Technical Note

Project:	Finchwood Park Parcel 13	SMA Ref:	7292.TN04
Subject:	Response to WBC Highways Comments	Revised:	–
Prepared by:	Tyler Andrews	Date:	16.07.2025
Checked by:	Kate Marshall	Date:	17.07.2025

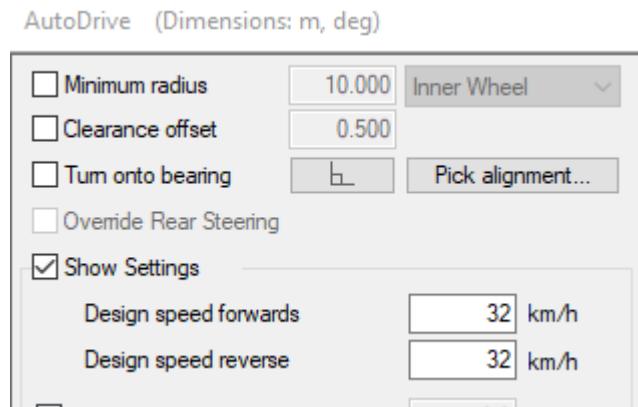
Comment 5:

The LHA also require further information is included with the swept path analysis:

- *Details of vehicle speed used for tracking of all vehicles.*
- *Details of clearance between wheels and kerbface. 300mm clearance required between wheels and kerbface.*
- *Large car measuring c.5.0m long and c.1.9m wide. The car tracked measures 1.769m wide and 4.8m long, which is narrower and shorter than many modern cars.*
- *Fire Tender tracking for a [Royal Berkshire Fire Service Volvo F8](#) which measures 8.51m long x 2.46m wide. The applicant has shown a DB32 Fire Appliance which only measures 2.18m wide.*

The vehicle speed that has been used for the tracking is 32kmh (20mph) as per the extract below:

We cannot achieve 300mm clearance from the kerb face with the refuse vehicle unless we encroach on the centreline of the road throughout the whole alignment. The refuse vehicle is 2.53m wide so this is already larger than the standard lane width, this is the same with the fire vehicle which is 2.46m wide. Cars can pass each other with 300mm clearance from the kerbline, but it isn't possible to achieve this clearance and stay on one side of the road with the larger vehicle. Larger vehicles can pass cars as discussed in the response to comment 4. We have proposed a 5m wide road as previously agreed with WBC and aligning with all the other parcels on the development. To achieve all of these requirements throughout the whole length of the road, the width would need to be over 6m throughout. The refuse vehicle will also only access the site once weekly, so this will not be a common occurrence.

The car and fire vehicles have been updated to show tracking of the vehicle types & sizes as listed above.

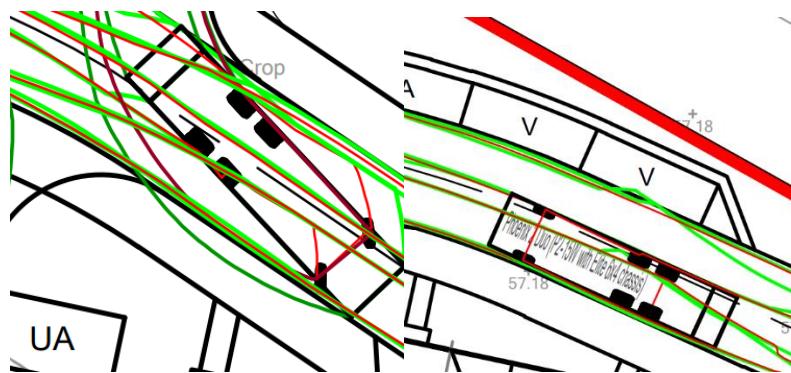
Comment 7:

The swept paths show several instances where the refuse vehicle overruns the kerb, visitor parking spaces or the centre line, as shown below.

Due to the width of the refuse vehicle, it is not possible to keep it solely within one lane. The tracking has been updated to show body overhang removed in all instances to protect the footways and pedestrians. There is no longer refuse tracking clashing with visitor spaces to protect parked cars. However, there are occasions where the refuse vehicle encroaches on the centreline, and this is inevitable due to the vehicle size and the roads having bends in the alignment.

REVISED DRAWINGS

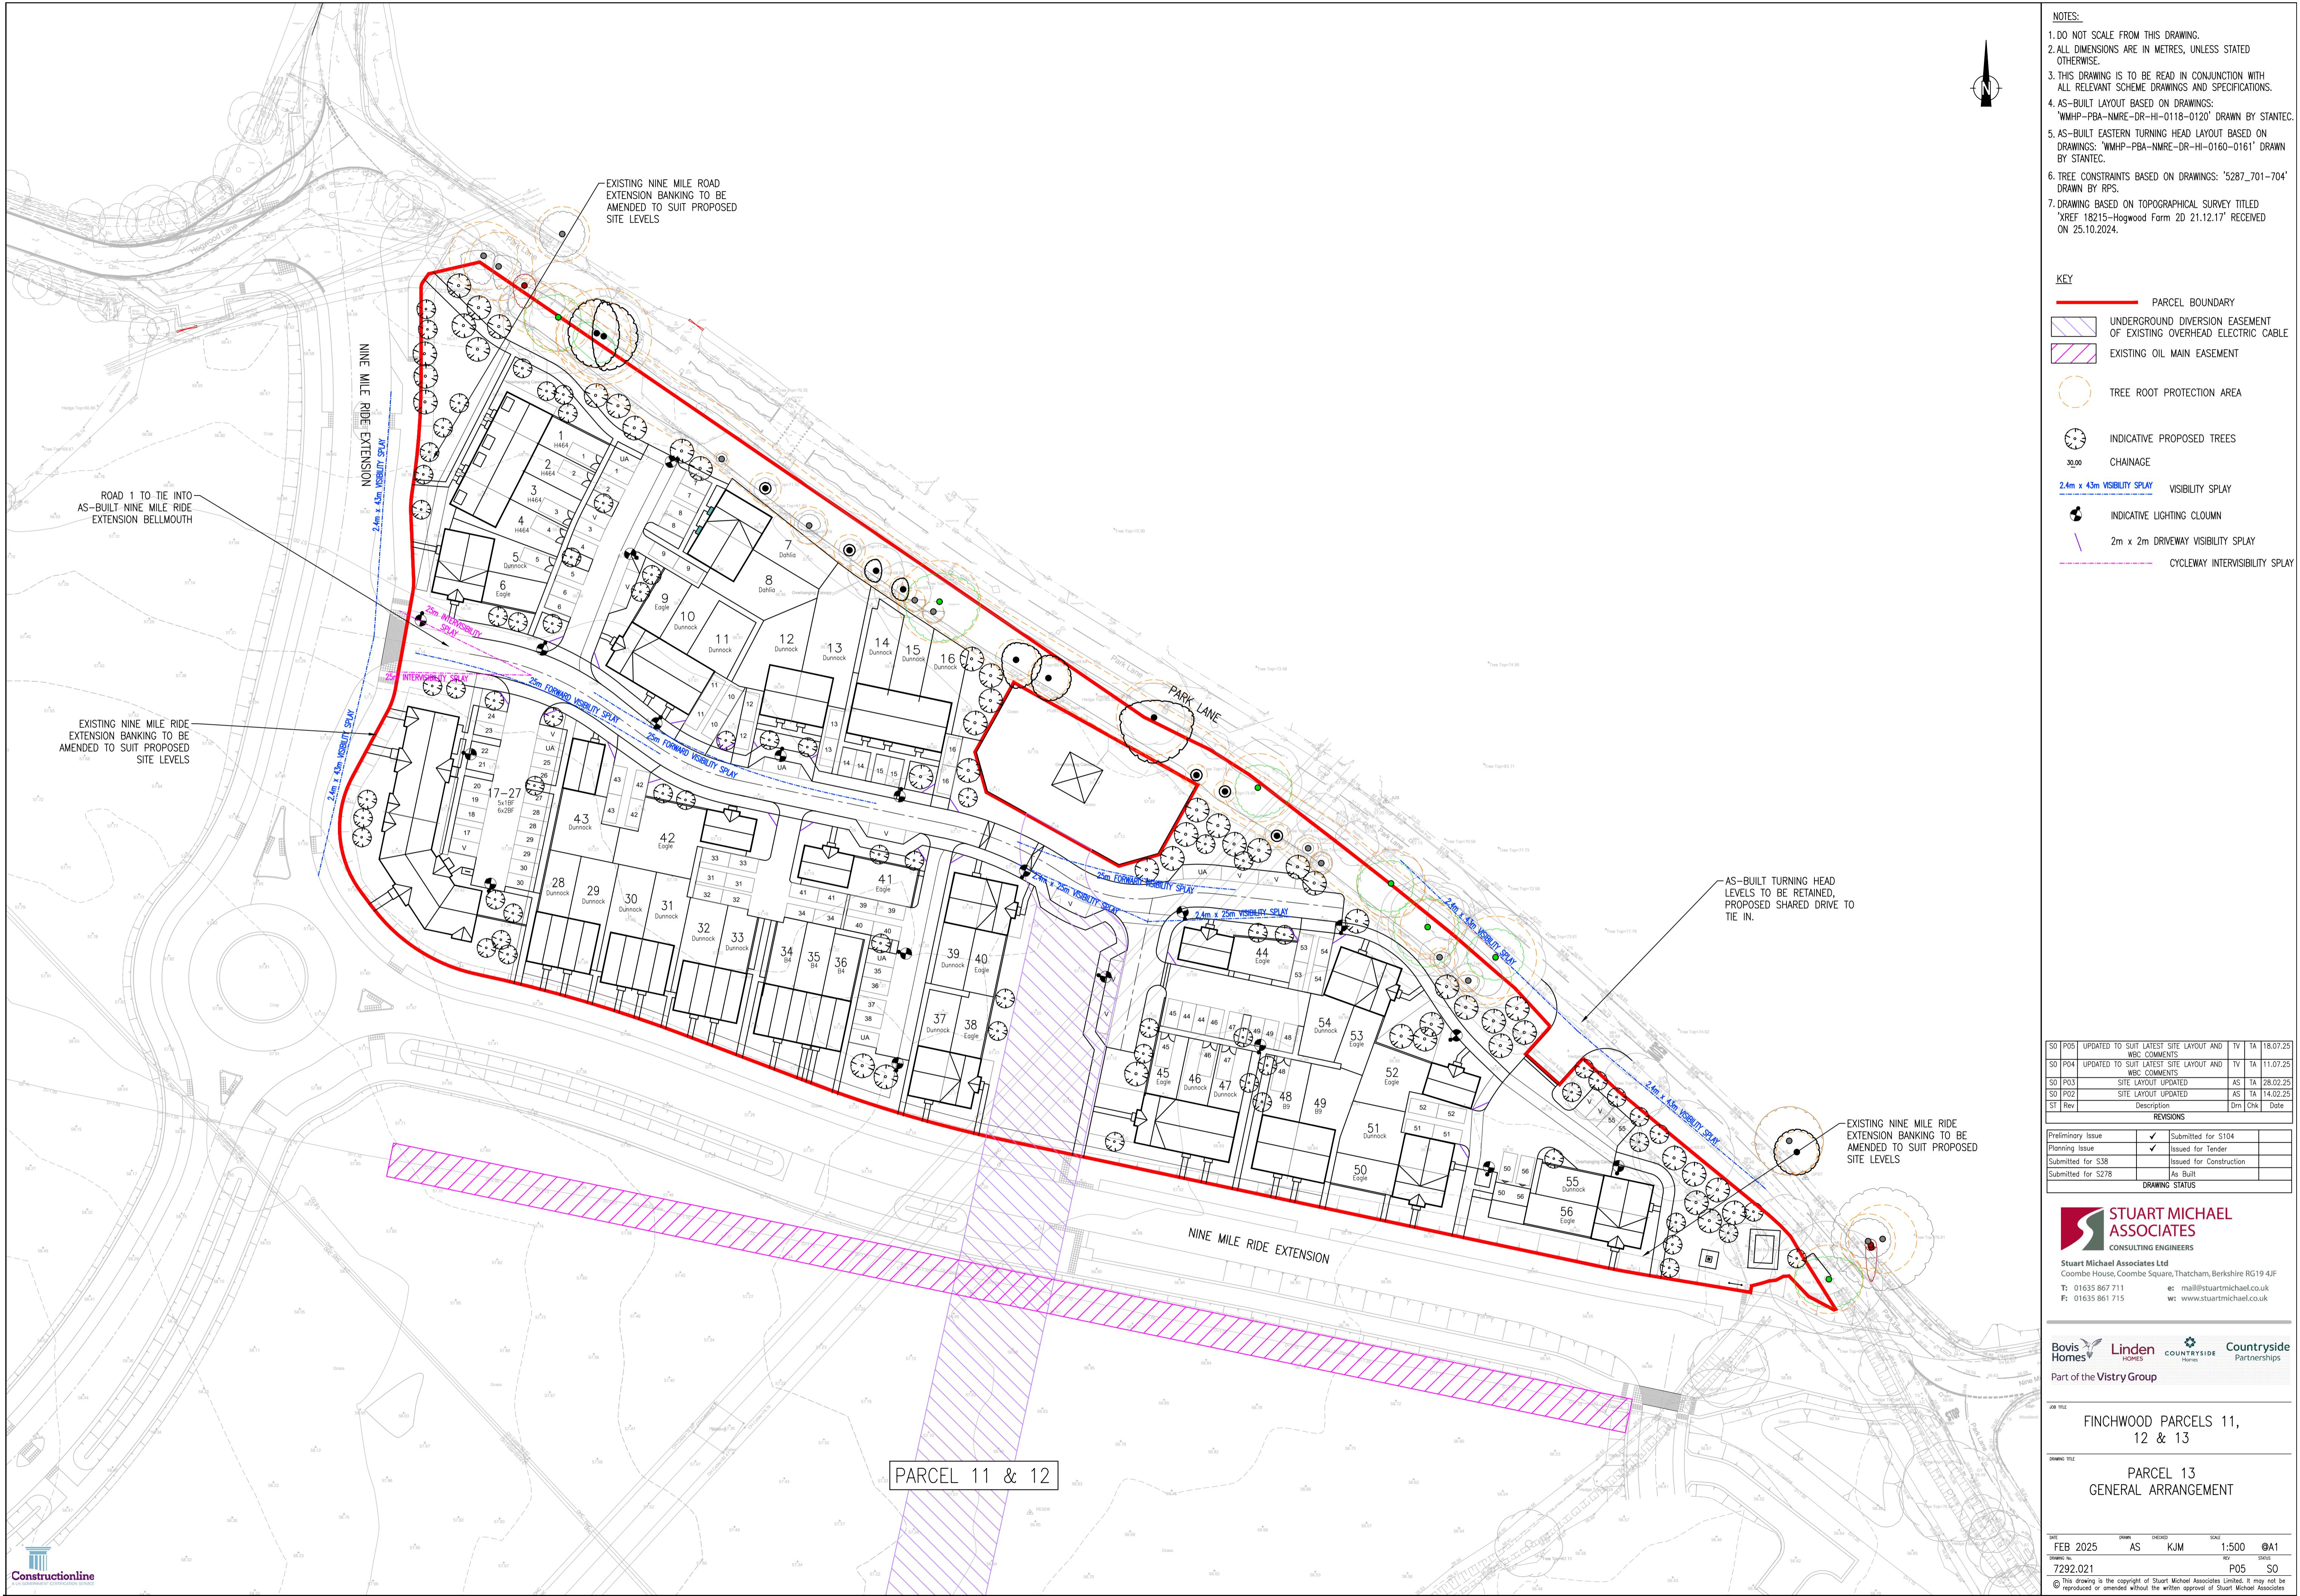
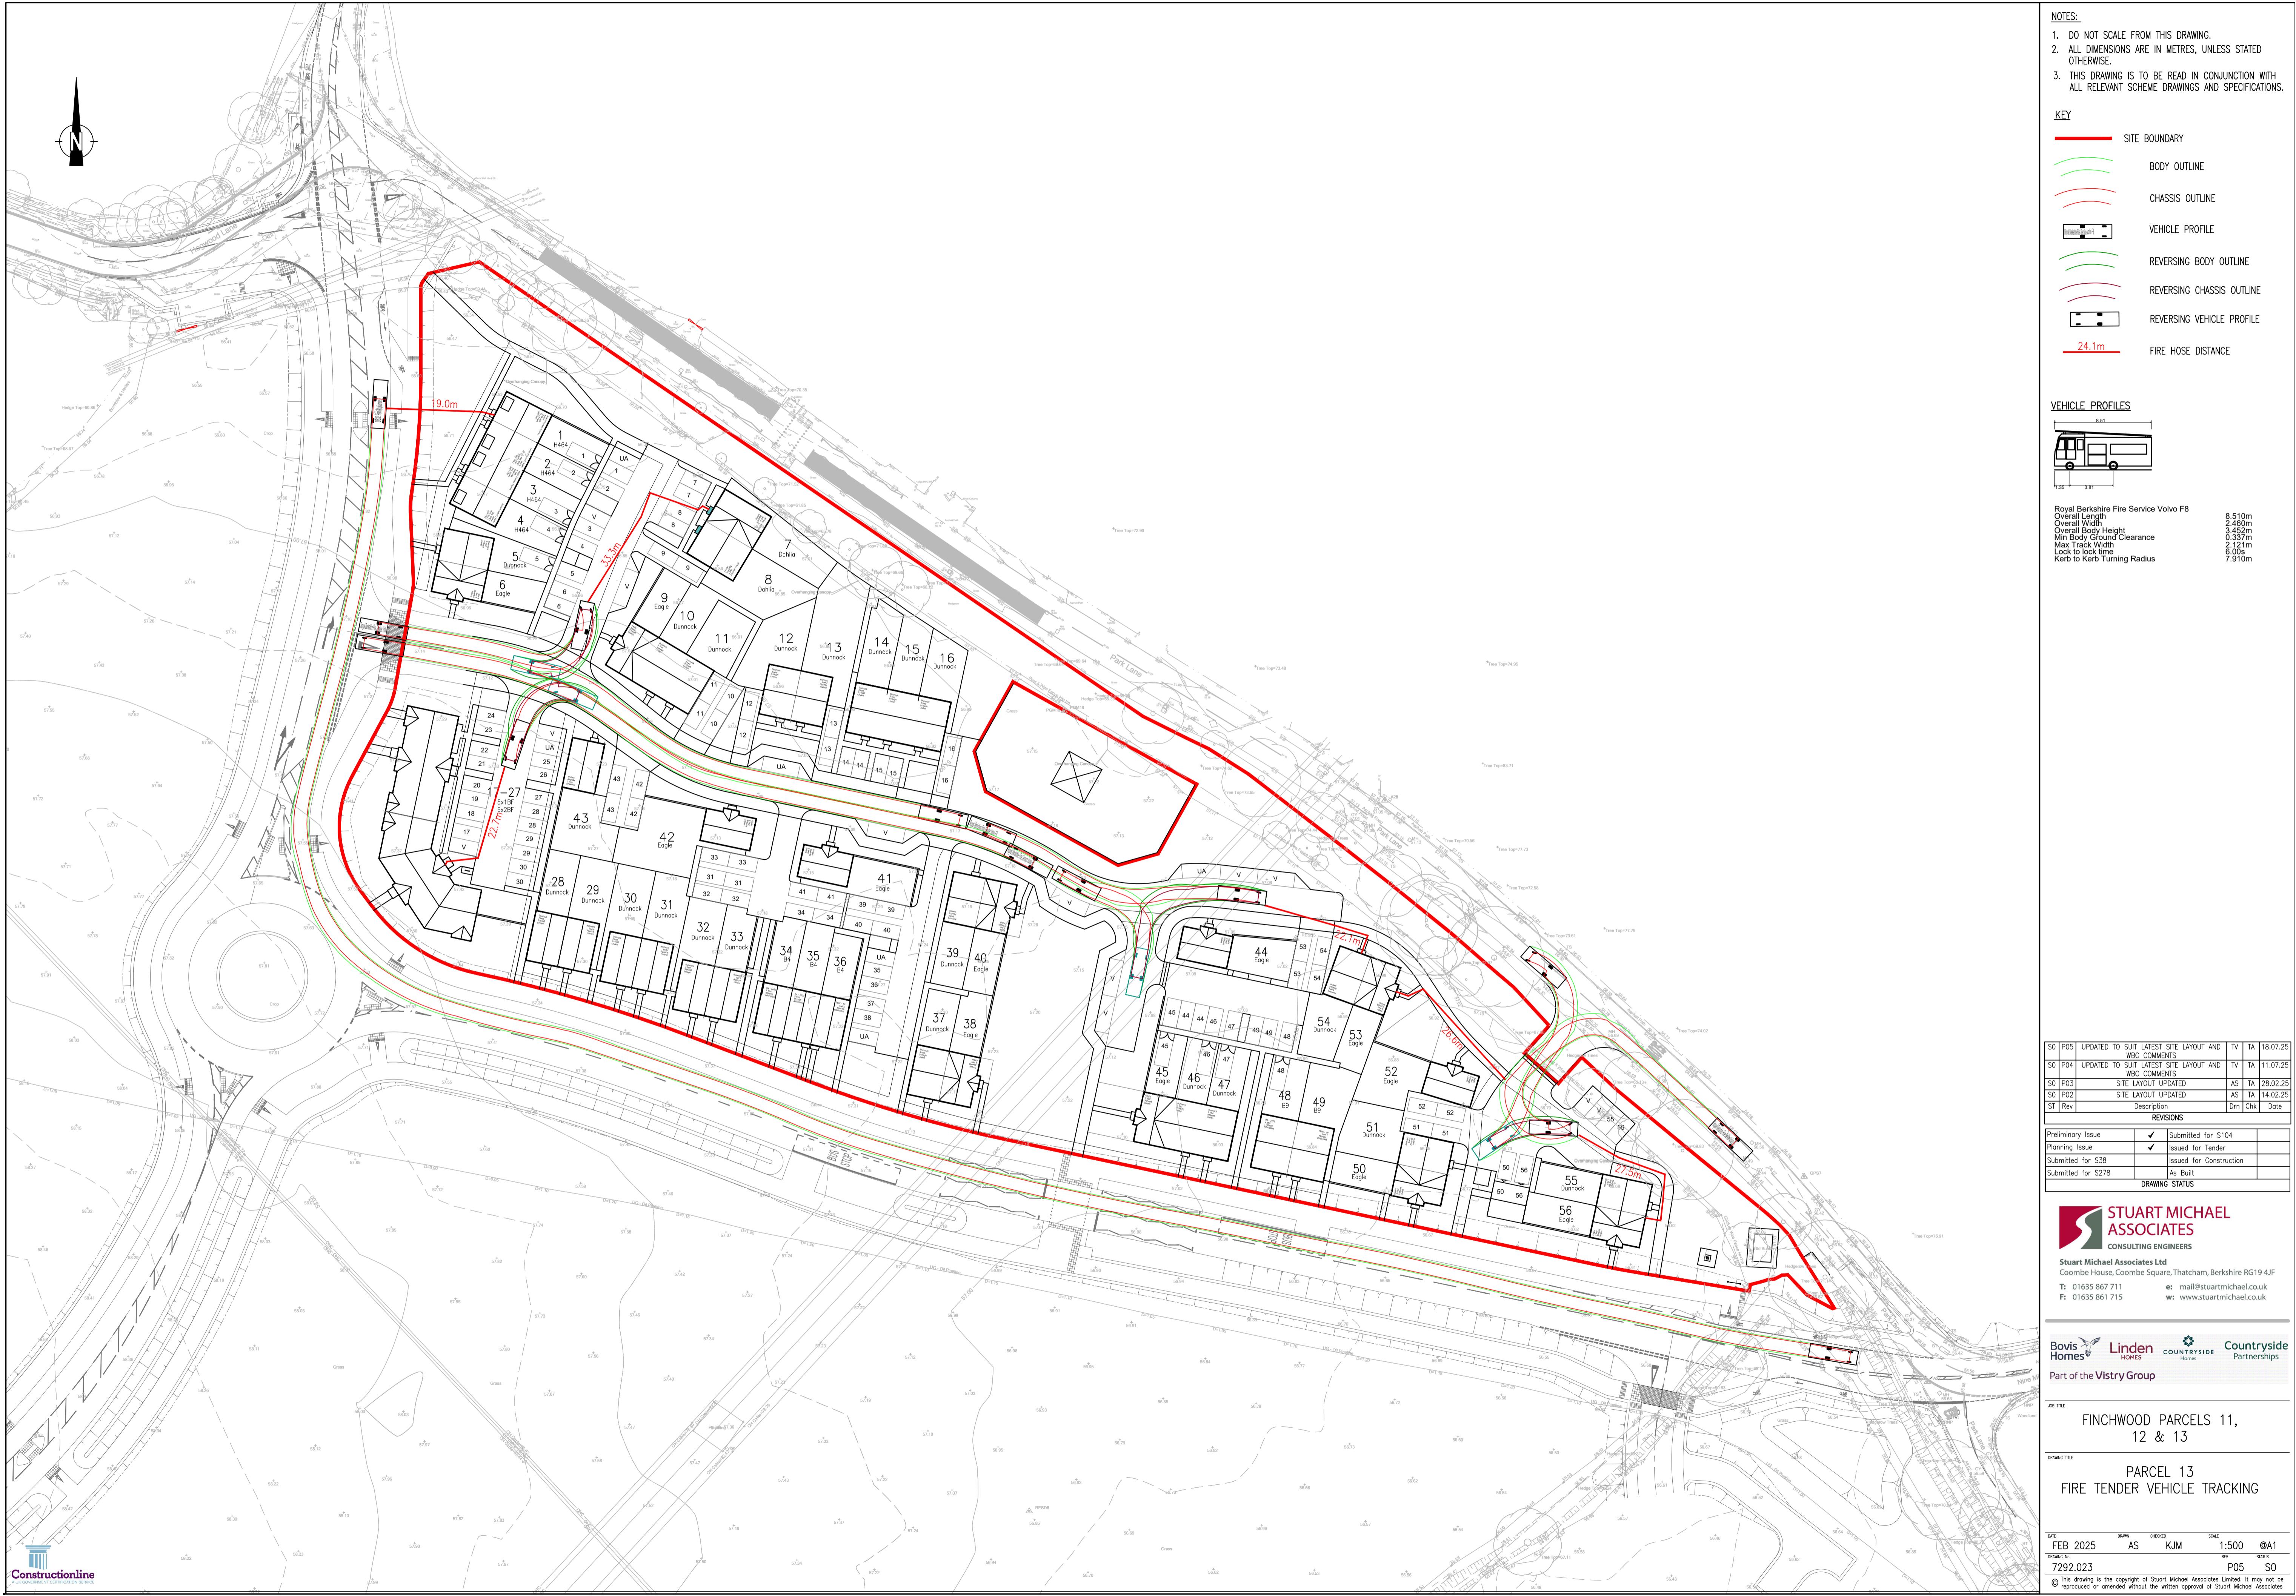
The LHA require a drawing which demonstrates suitable forward visibility for vehicles travelling along the internal site access road.

The design should naturally convey appropriate design speeds to drivers, with a target speed of 20-25mph on estate roads. Such a requirement relies on features at 50-80m centres. Whilst this could take the form of traffic calming, good design should avoid the need for engineering features.

The internal site access road is circa. 170m long thus vehicle speeds would not be controlled by the road alignment alone. It will be necessary to revisit this part of the design.

Forward visibility splays have now been added where required and these are shown on the general arrangement drawings. Refer to general arrangement drawing 7292.021 included under Appendix A on this note.

Speed control has been considered in the design of the road network by the narrowing of the road and bend to the front of plots 9 & 43 that will act as a speed control for vehicles entering and exiting the site. The rest of the road alignment has been reviewed, and a raised table is now proposed to the front of plot 40 to act as a traffic calming feature. Refer to general arrangement drawing 7292.021 included under Appendix A on this note.

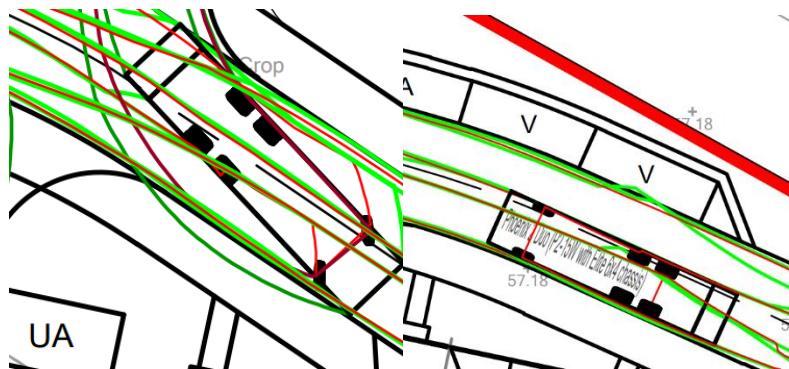
15. The swept paths show several instances where the refuse vehicle overruns the kerb, visitor parking spaces or the centre line, as shown below.
